Bayer MaterialScience LLC
125 New South Road
Hicksville, New York
USEPA ID#: NYD002920312
ICM Additional PCB Soil Removal Work Plan Modification

On behalf of Bayer MaterialScience LLC (Bayer), this letter responds to New York State Department of Environmental Conservation (NYSDEC) comments on the *Interim Corrective Measure Additional PCB Soil Removal Work Plan* (ARCADIS, November 2008) for the above referenced site. The NYSDEC comments addressed herein are provided in your e-mail correspondence dated November 24, 2008. The comments and Bayer's responses were discussed during a November 25, 2008 telephone conference call with the NYSDEC, Bayer, and ARCADIS.

FIGURE 4

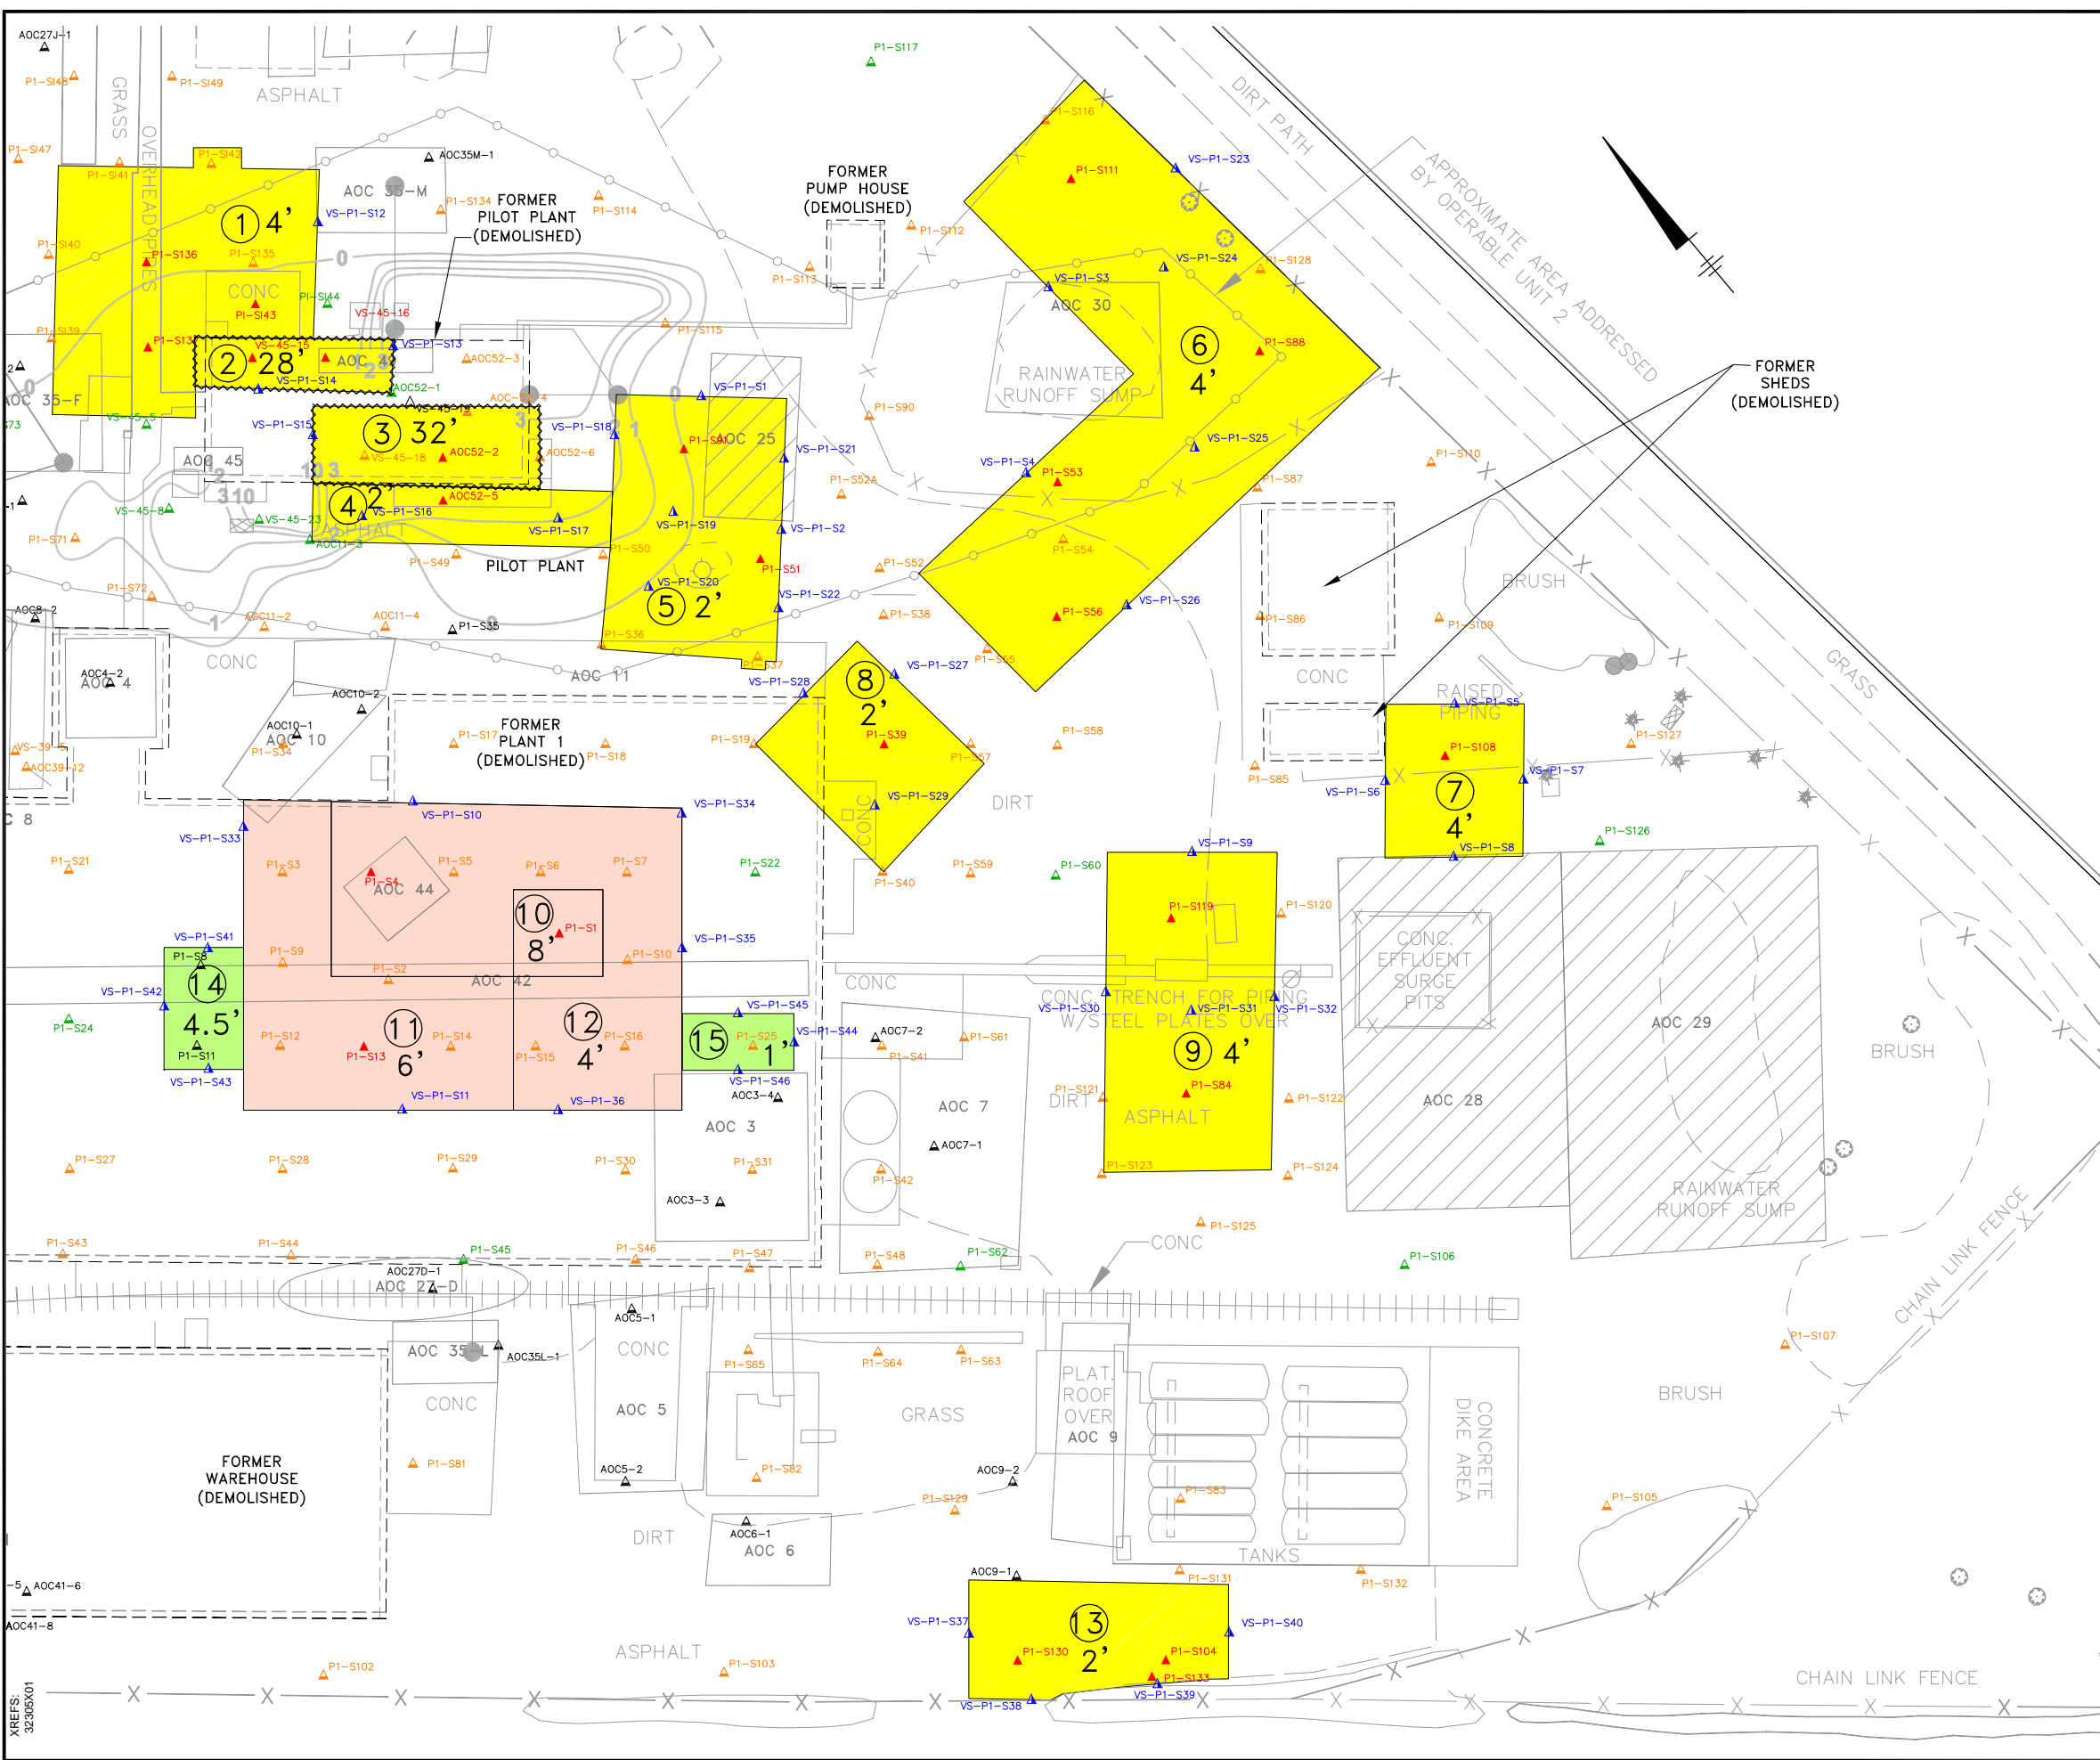
Excavation Area 1: P1-S42 should be included in the excavation area as PCB concentration is borderline (49 ppm) at this location.

Excavation Area 5: P1-S37 should be included in the excavation area as PCB concentration is 50 ppm.

Excavation Area 11: Two sampling points adjacent to this area, P1-S8 and P1-S11, had high total VOCs. Total VOCs at P1-S8 were high for depths ranging from 0 to 4.5' bgs. Total VOCs at P1-S11 were high for depths ranging from 0 – 2.5' bgs.

These two areas can be addressed as part of the excavation Area 11, or as separate areas (see revised Figure 4).

Excavation Area 12: The sampling point adjacent to this area, P1-S25, had high total SVOCs (890 ppm) in surface soils (0 – 0.2'). These SVOC's included carcinogenic PAHs which should be removed.

Excavation Area 13: It is not clear why excavation in this area stretches from P1-S103 to P1-S132, except that these points are the only two where PCB concentrations fall below 50 ppm. Would it be more practical to decrease the excavation area and include several verification samples?

It appears that only sidewall verification samples are being proposed, since there are already analytical results for vertical delineation of soils. However, some of the excavation areas are large and there are not enough verification samples to adequately verify that PCB contaminated soils from the bottom and sides have been removed. At some of the excavation areas, additional verification samples are needed for the sidewalls and bottom. See the Revised Figure 4 which shows additional sampling locations with dark pink circles and additional areas in dark pink outlines.

As discussed during the November 25, 2008 conference call, soil sampling location P1-S42 identified in the comments should actually be soil sampling location P1-S142. Soil at location P1-S142 will be removed as requested. See attached Figure 4 for Excavation Area 1 extended excavation limits and revised Table 3 for the modified soil removal volume.

Acknowledged. See revised Figure 4 for Excavation Area 5 extended excavation limits and revised Table 3 for the modified soil removal volume.

As suggested by the NYSDEC, the soil in and around soil sampling locations P1-S8 and P1-S11 (to be identified as Excavation Area 14) will be removed to a depth of 4.5 feet. The limits of Excavation Area 14 are shown on revised Figure 4. A sidewall and bottom verification sample will be collected from each of the three sampling locations suggested by the NYSDEC in Comment 10. The sidewall samples will be collected from a depth of 2.0-2.5 feet below ground surface (bgs) and the bottom samples will be collected from a depth of 4.0-4.5 feet bgs. The proposed sampling locations and sampling intervals are identified in attached Table 4, and the additional soil removal volume is reflected in revised Table 3.

Soil in and around sampling location P1-S25 (to be identified as Excavation Area 15) will be removed to a depth of 1 foot bgs. The limits of Excavation Area 15 are shown on revised Figure 4, and the additional soil removal volume is identified on revised Table 3. Proposed surface soil and bottom verification samples will be collected from each of three sampling locations suggested by the NYSDEC in Comment 10 and shown on revised Figure 4. The surface soil samples will be collected from a depth of 0.0-0.2 feet bgs and the bottom samples will be collected from a depth of 0.5-1.0 feet bgs. The proposed sampling locations and sampling intervals are identified in attached Table 4.

The limits of Excavation Area 13 have been decreased as suggested and are shown on revised Figure 4. The reduced soil removal volume is reflected in revised Table 3. These limits are contingent on the results of additional verification sampling. A sidewall and bottom verification sample will be collected from each of the four sampling locations suggested by the NYSDEC. The sidewall samples will be collected from a depth of 0.5-1.0 feet bgs and the bottom samples will be collected from a depth of 1.5-2.0 feet bgs.

As discussed during the November 25, 2008 conference call, additional sidewall and bottom verification soil sampling will be performed at the locations indicated on the figure provided in the November 24, 2008 e-mail correspondence. See revised Figure 4 for the additional verification soil sampling locations and Table 4 for the proposed sampling locations and sampling intervals.
